SAN FRANCISCO PLANNING DEPARTMENT

Discretionary Review Analysis

Date: July 1, 2010
Case No.: **2008.0430DV**
Project Address: **2299 MARKET STREET**
Permit Application: **2009.10.06.8389**
Zoning: Upper Market NCD (Neighborhood Commercial) District
50-X Height and Bulk District
Block/Lot: 3564/091
Project Sponsor: Angus McCarthy
365 Pacheco Street
San Francisco, CA 94116
Staff Contact: Michael Smith – (415) 558.6322
michael.e.smith@sfgov.org
Recommendation: **Do Not Take DR and approve project as proposed**

PROPOSED PUBLIC RIGHT OF WAY IMPROVEMENTS

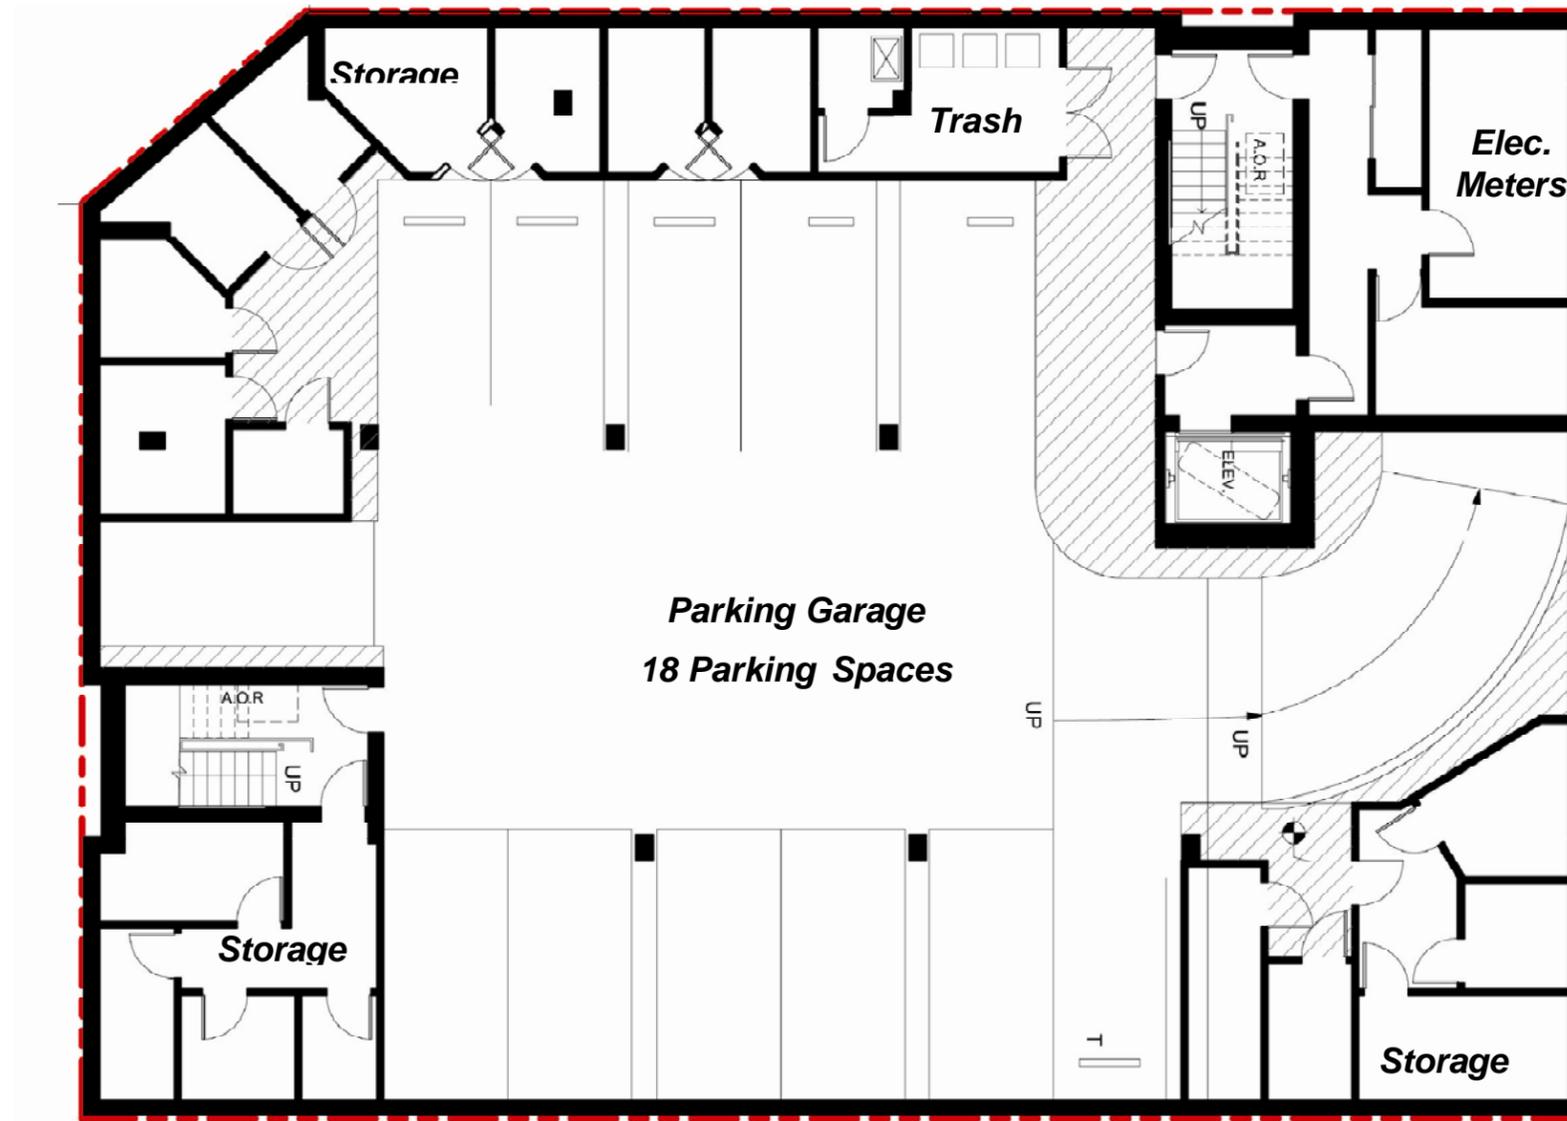
The proposed 2299 Market Street project does not mitigate its impacts on pedestrian safety or traffic conditions, nor does the project sponsor intend to provide any community improvements contributions beyond standard required site frontage sidewalk work, irrespective of the intersection environment outlined above,. Yet, **the Upper Market Community Plan specifically calls out "public realm recommendations" for crosswalk and corner safety improvements at Market x 16th and Market x Noe, immediately in front of the project site** (see Attachment 9). None of those improvements are being provided by this project, while a full underground parking garage is

Sidewalk pedestrian flow will be further constricted by proposed large “bio swale planters” along the Market Street and 16th Street frontages of the 2299 Market Street site. The rendering in Attachment 10 shows two of these planter boxes, and the 311 Notice plans clarify that these boxes will continue along the entire 16th Street frontage. Given the heavy pedestrian activity and the essentially continuous crosswalk spanning 16th Street and Noe Street in front of the project site, these planter boxes are very likely to be obstacles and potential hazards. **The project should be *increasing* sidewalk capacity for pedestrian circulation at this very busy intersection rather than limiting it.**

The three large mature street trees will be preserved and nine (9) new street trees will be planted. Subject to approval by the Department of Public Works, traffic calming “bulb-outs” have been included in the side walk design, which will increase the width of the side walk at the corner of Noe/Market/16th Street providing a public gathering place. Landscaped bioswale and

The project has been designed to include traffic calming "Bulb Outs". The bulb outs in essence widen the sidewalk at 16th Street by 9' and virtually double the width of the sidewalk at Market and Noe Streets. This sidewalk improvement is consistent with the proposed Upper Market Community Plan and the Market/Octavia Plan policies regarding improvements for the public realm and the community. This sidewalk improvement alleviates any potential overcrowding of the sidewalk area at this intersection.

Proposed Design – View from Market Street (select street trees not shown for clarity)

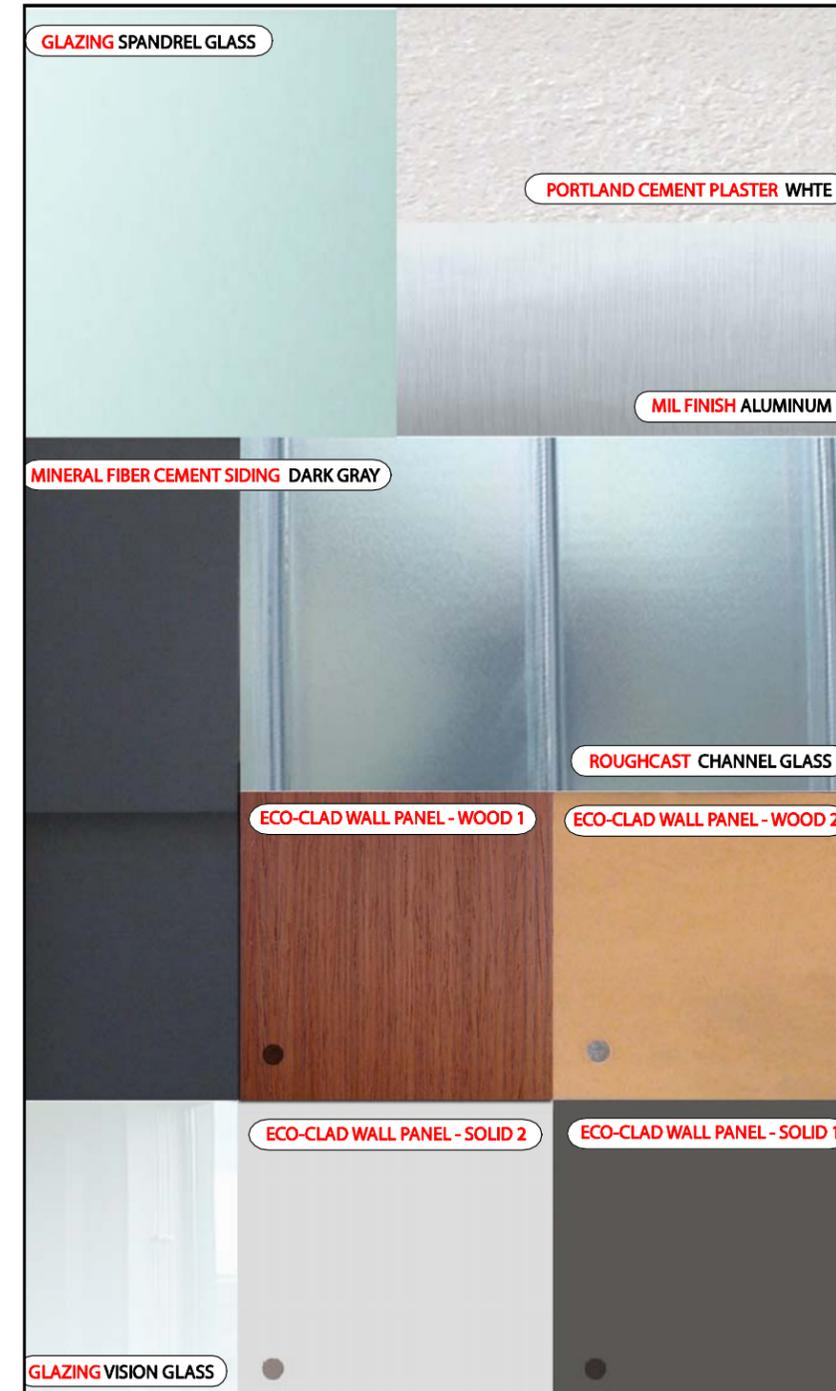
being built directly adjacent to the 16th Street crosswalk. The 2299 Market Street development rendering by the sponsor (see Attachment 10) shows the building in complete isolation from its pedestrian context and other complicated configurations at this intersection. Incidentally, this rendering was not included in 311 Notice plans to the community. The crosswalks spanning 16th Street and Noe Street along the frontage of the project site have been overlaid on the rendering for the Attachment 10 here.

② PLAN - 1ST FLOOR PROJECT DATUM
1/8" = 1'-0"

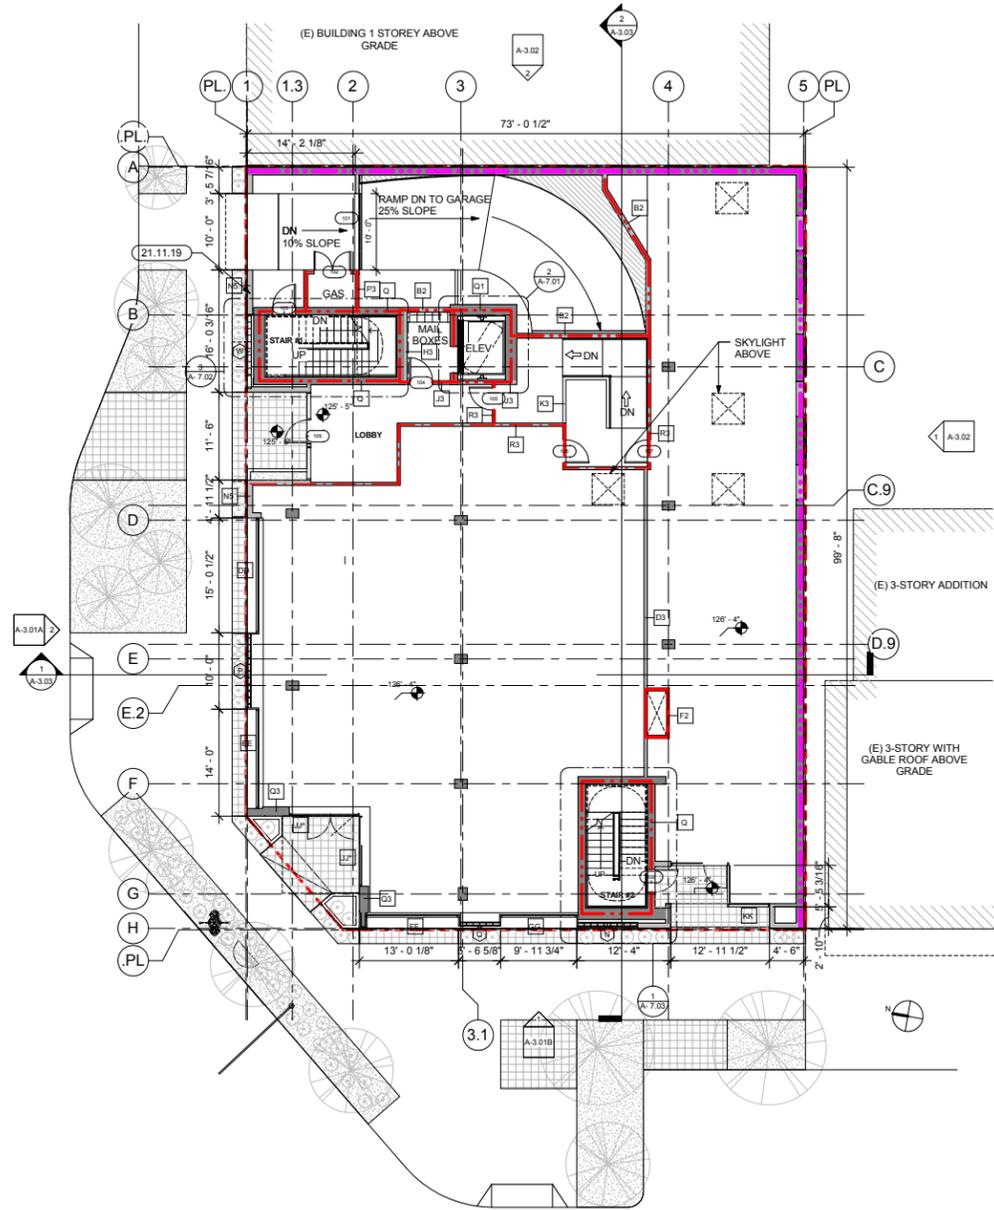
5. **Ground floor Retail Store Ceiling Height:** The retail storefront ceiling height does to conform to the design guideline of the Market/Octavia Plan.

Ground floor retail – Provide full height 15-foot ceilings for all the ground floor retail space consistent with the Upper Market NCT zoning and the policy intent of the Upper Market Community Plan.

The retail space on the ground floor for the 2299 Market Street proposal does not conform with the 15-foot ceiling height policy for retail space of the Market/Octavia Plan or the Upper Market Community Plan. Great emphasis has been placed on taller retail spaces by the community through these planning processes. The project sponsor has created an illusion of tall retail space at the Market Street frontage of the building, but the ceiling at the interior of the ground floor drops back down to ten feet.

In response to the concerns raised by the DR requestors the sponsor has increased the ceiling height in the second commercial space on Noe Street from 10-feet to 14-feet in height. No other changes have been made since the DR was submitted.

The Upper Market NCT zoning allows a five-foot height bonus to increase the ceiling height in ground floor commercial spaces. The Upper Market NCD has no such allowance. As a result, the plans that were noticed to the public indicated a 10-foot ceiling height for the commercial space on Noe Street. The Department supported the original design because increasing the ground floor ceiling height for the second commercial space would have resulted in the loss of a dwelling unit and the space is a secondary commercial space that helps the base of the building transition to the lower height commercial spaces on Noe Street. The sponsor has since revised the project using different construction techniques to increase the ceiling height of the Noe Street commercial space from 10-feet to 14-feet in height.

5. **Ground floor Retail Store Ceiling Height:** To address the concerns raised by the neighbors, the storefront clear ceiling height has been increased to 14' by redesigning the building without the benefit of a higher height limit conferred on properties in the Market/Octavia Plan area. The building plans are now for a concrete structure, with consequential higher construction costs, instead of a wood framed building. One of the fundamental design principles in the Market/Octavia Plan is 12' to 15' ceiling height for storefronts with 15' ceiling height on Market Street.
